Addendum No.1
to
CONSTRUCTION DOCUMENTS
for

May 21, 2025
2023159.00

NCISD New District Administration Building
21330 Valley Ranch Parkway
New Caney, TX. 77357
May 20, 2025

1 WASTE AND VENT RISERS DIAGRAM
Scale:

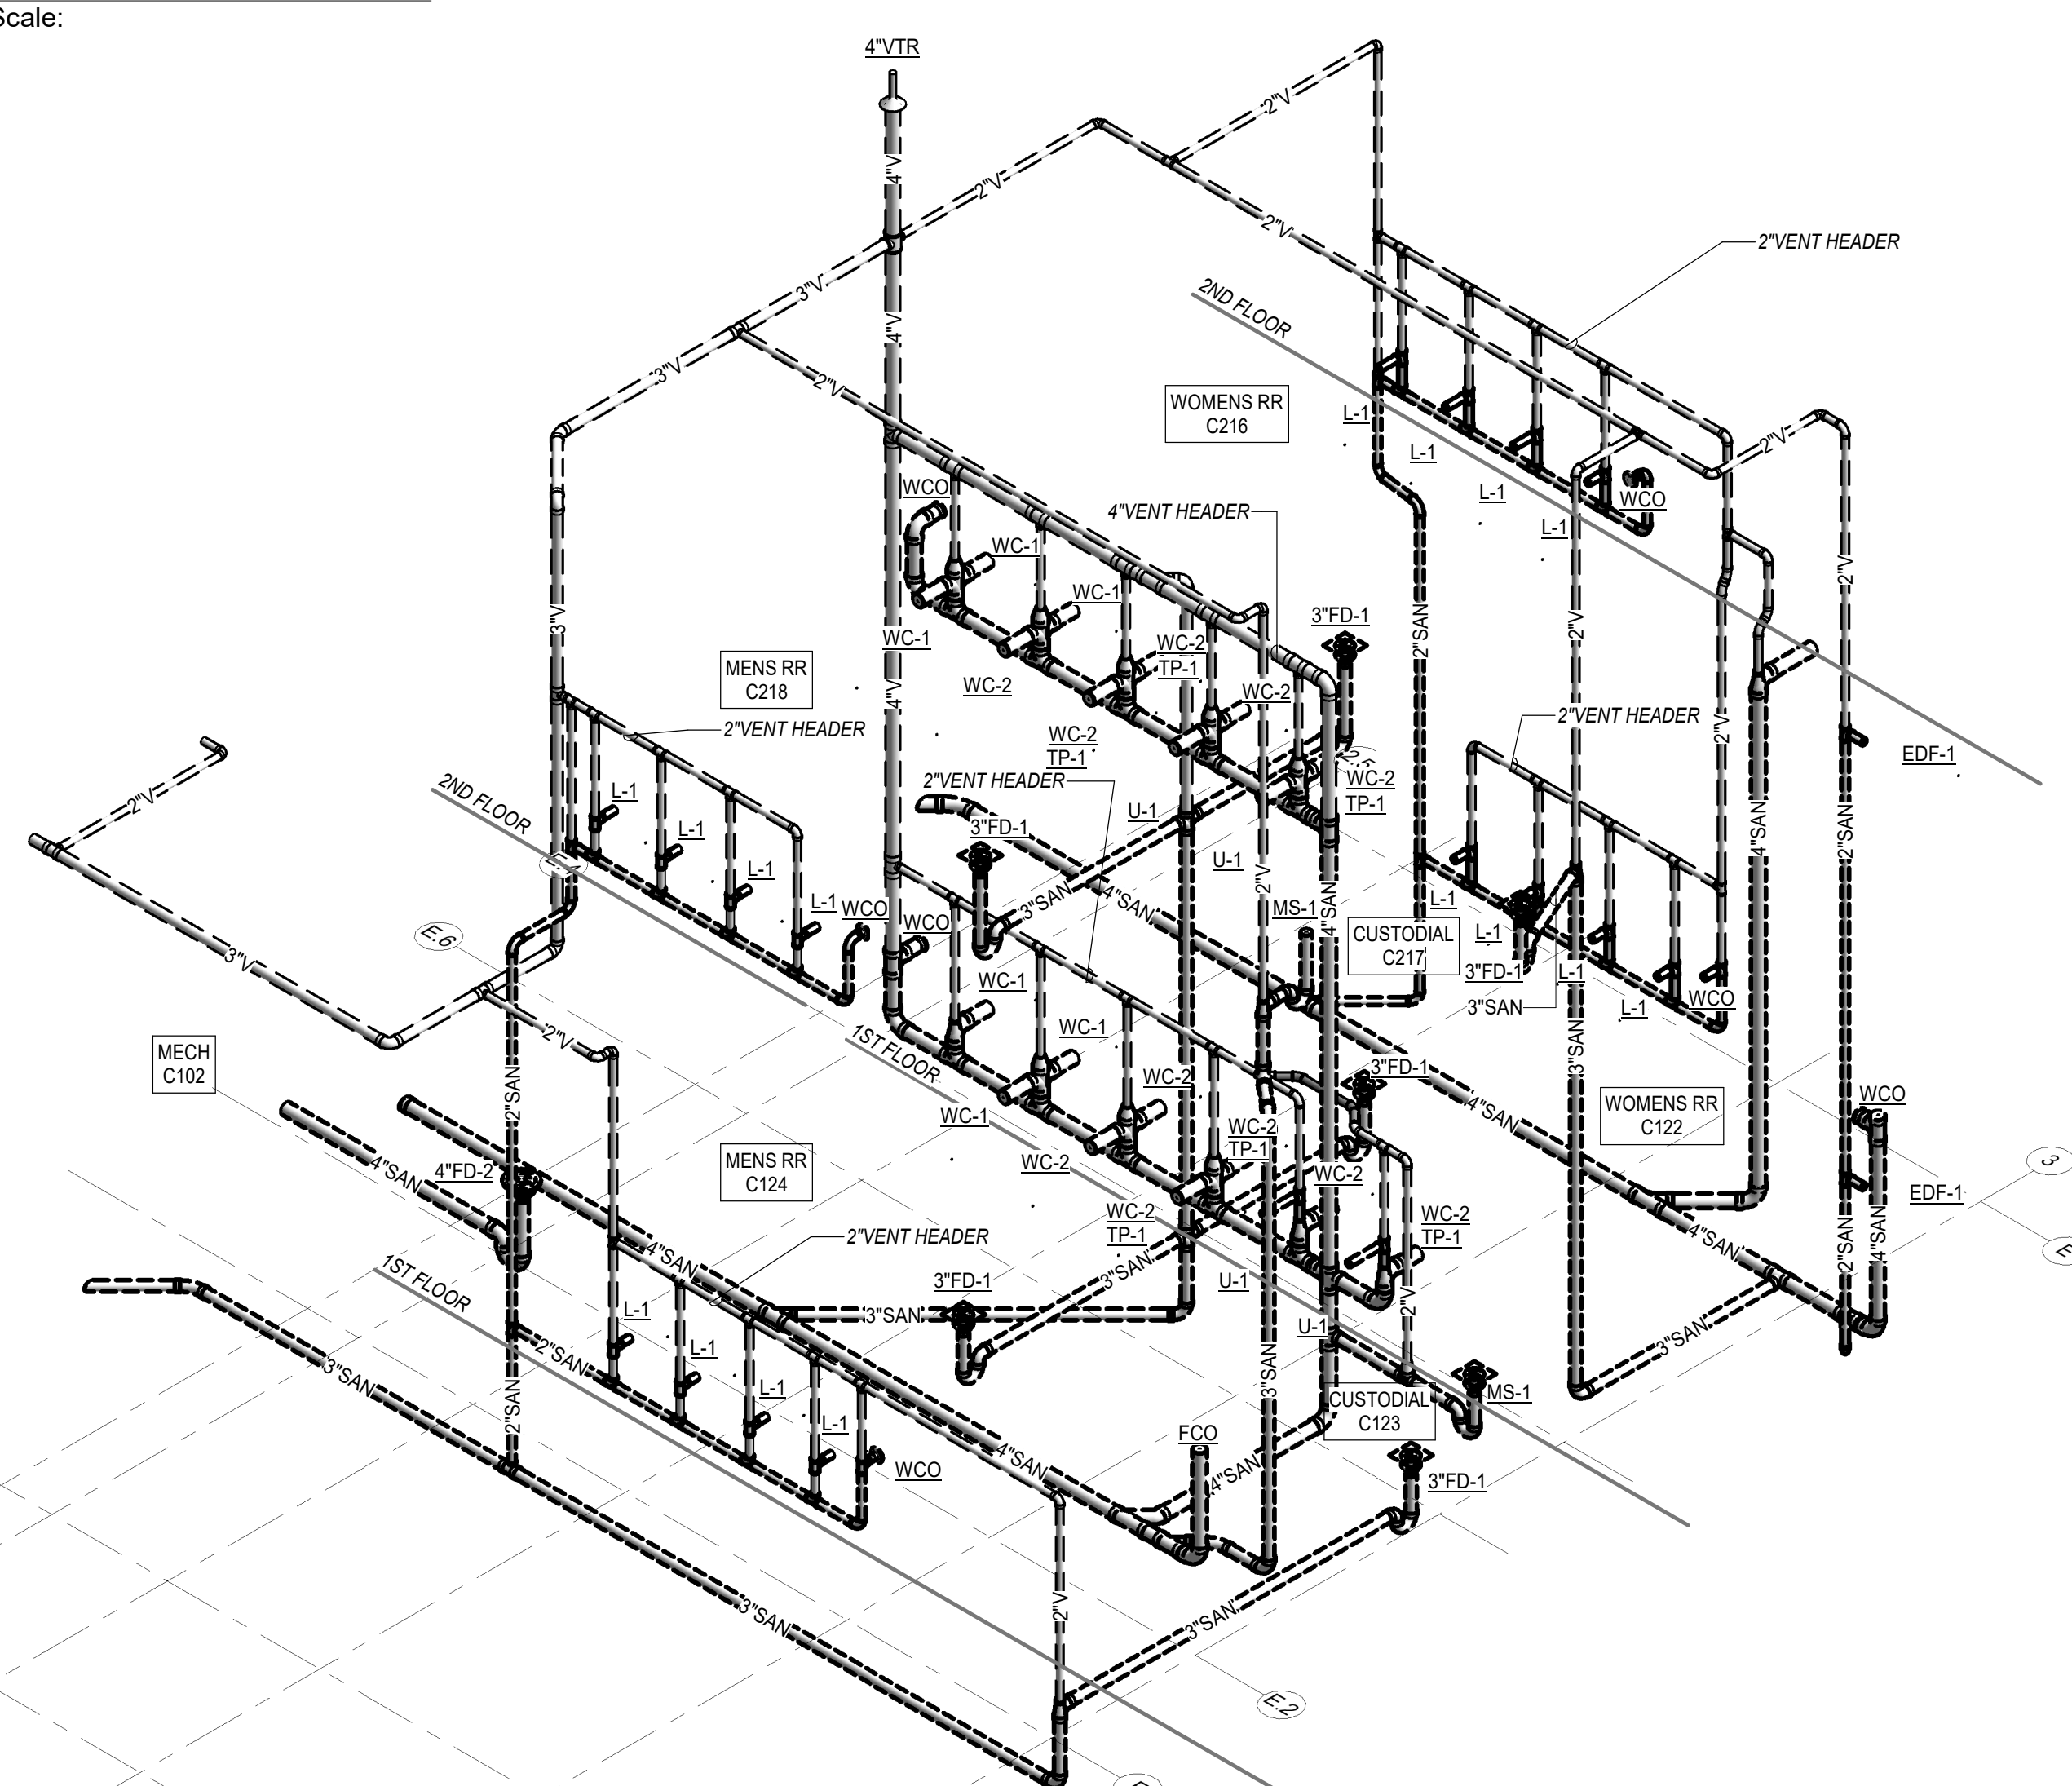
NEW DRAWING SHEETS

1. P-501- PLUMBING RISER DIAGRAMS
 - a. Add sheet in its entirety.

TECHNOLOGY ENLARGED SITE PLAN

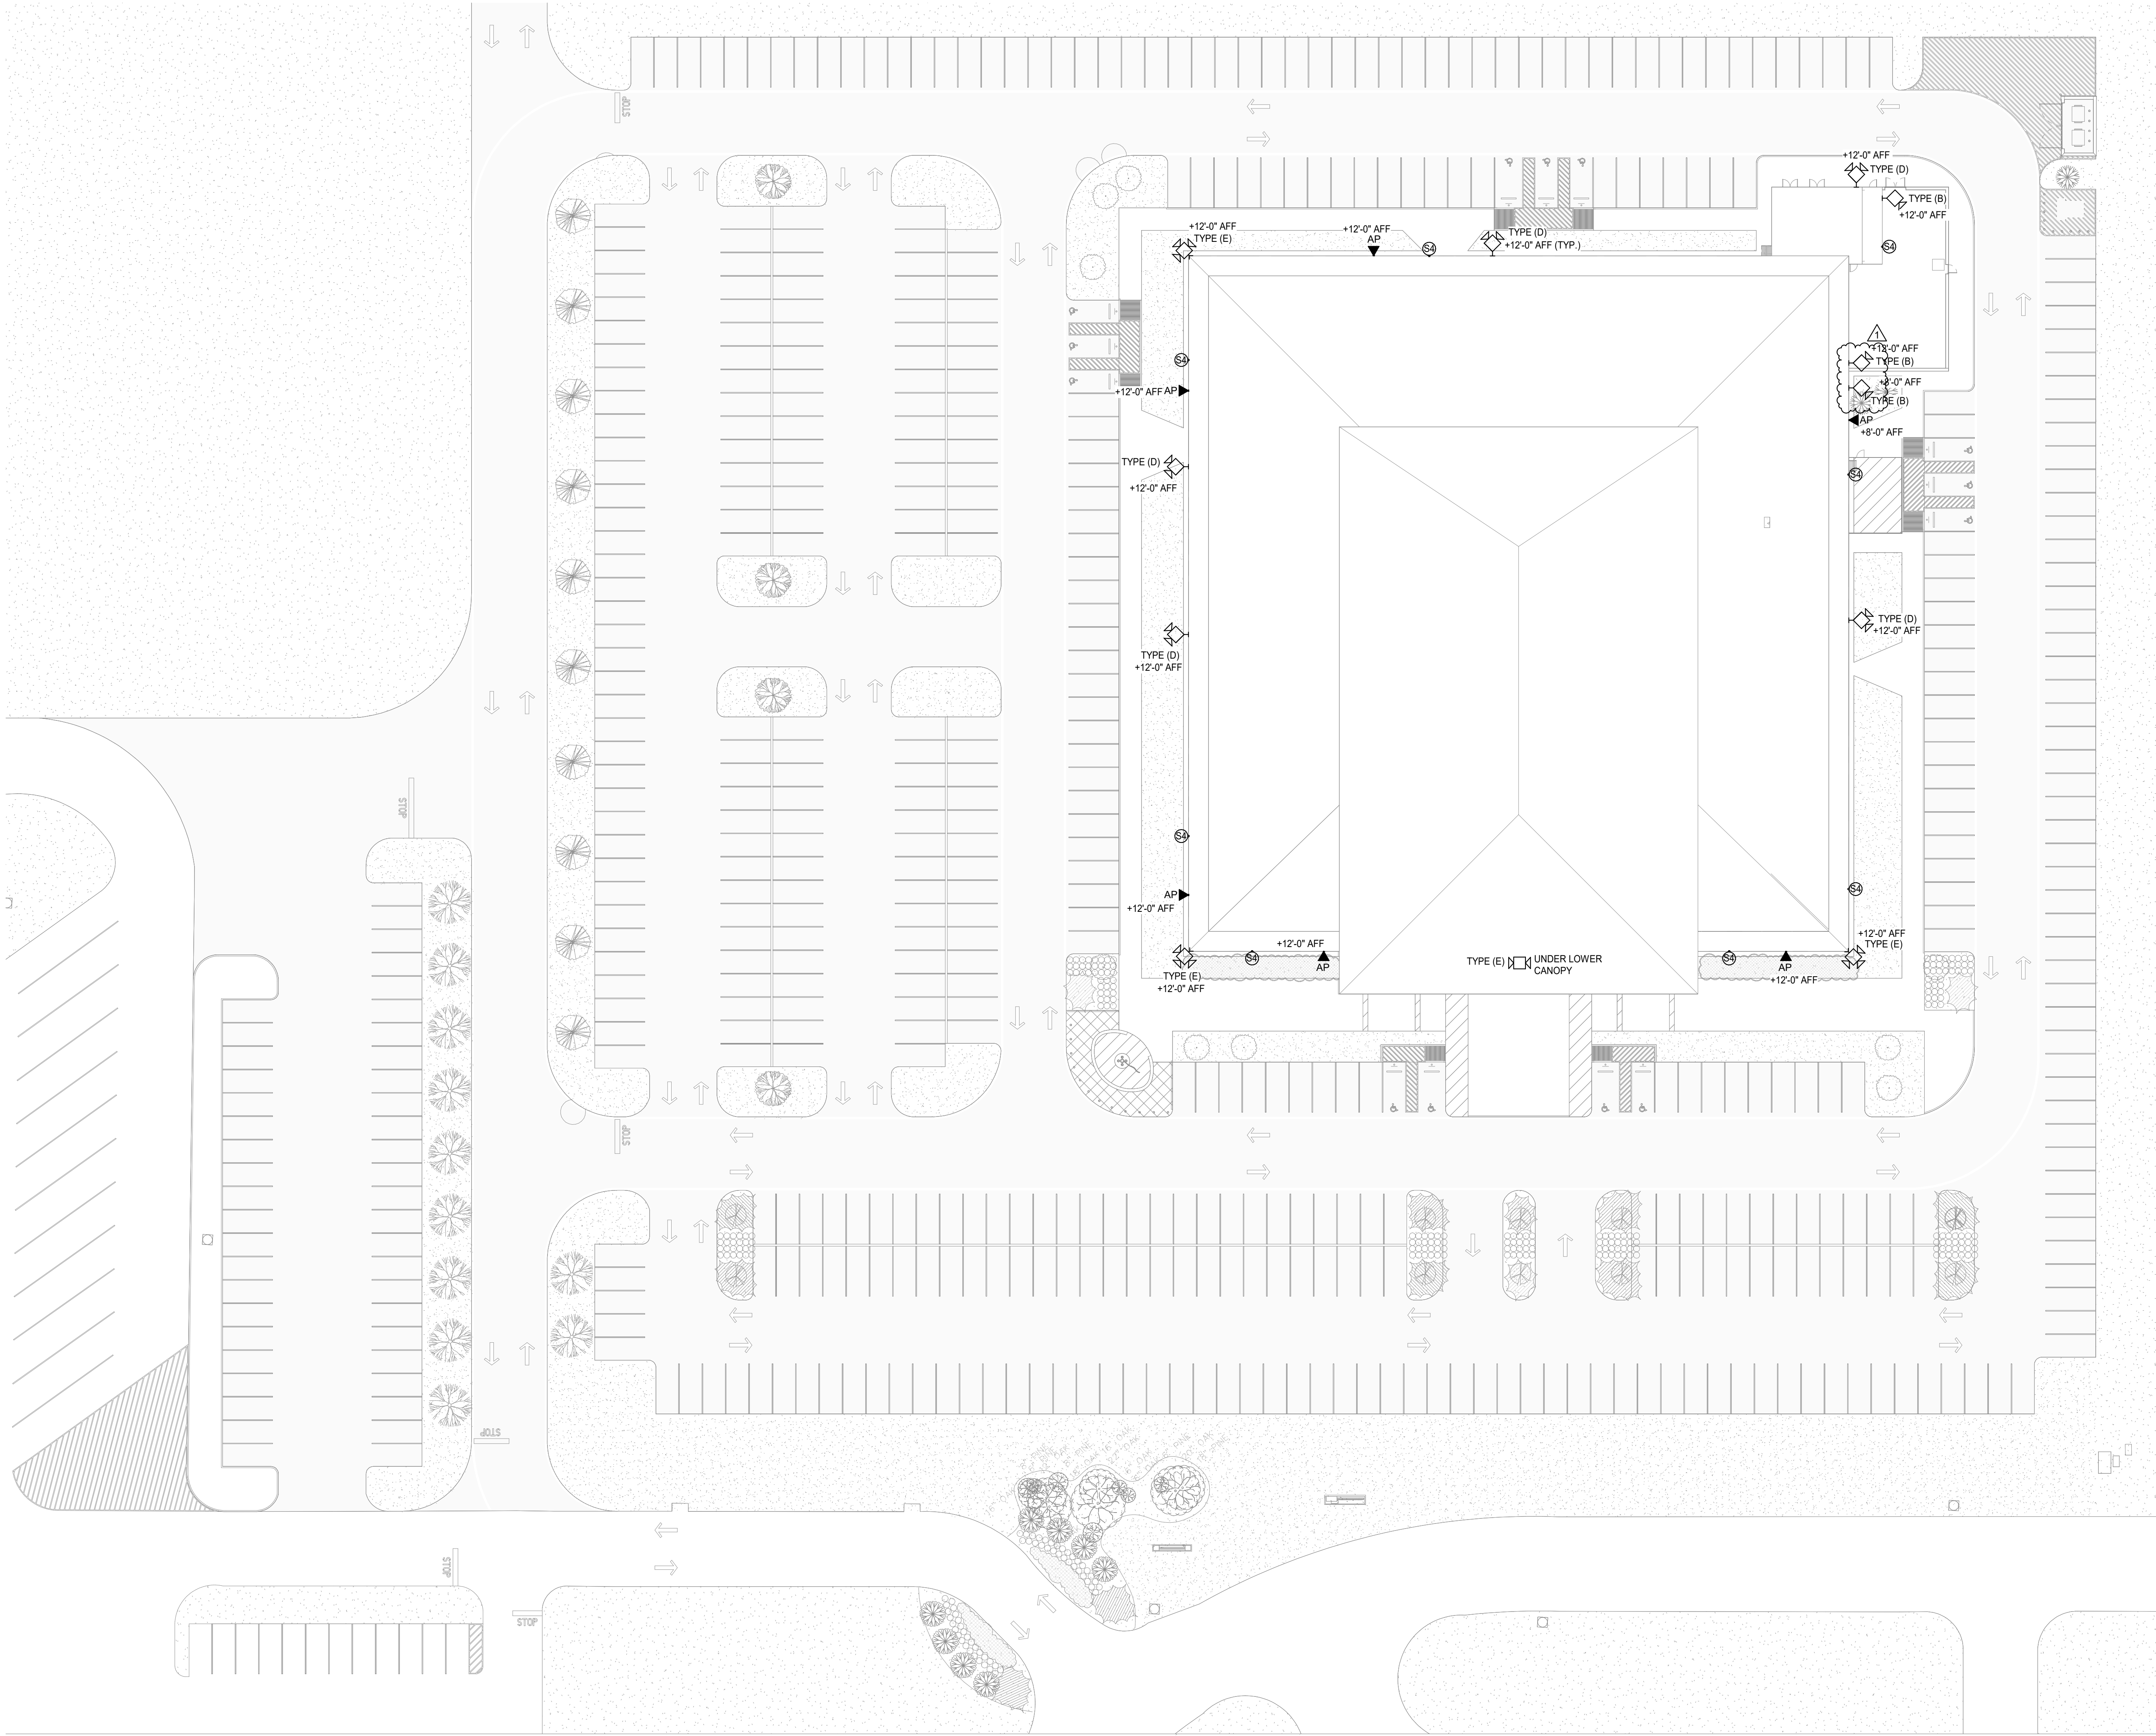
1. SHEET P-100 – PLUMBING SITE PLAN
 - a. Refer to revised sheet for addition of Storm GPM at outfalls.
2. SHEET P-127 – PLUMBING ROOF PLAN
 - a. Refer to revised sheet for updated roof areas and GPM flows.
3. SHEET T-100.2 - TECHNOLOGY ENLARGED SITE PLAN
 - a. Revise (2) cameras orientation as shown.
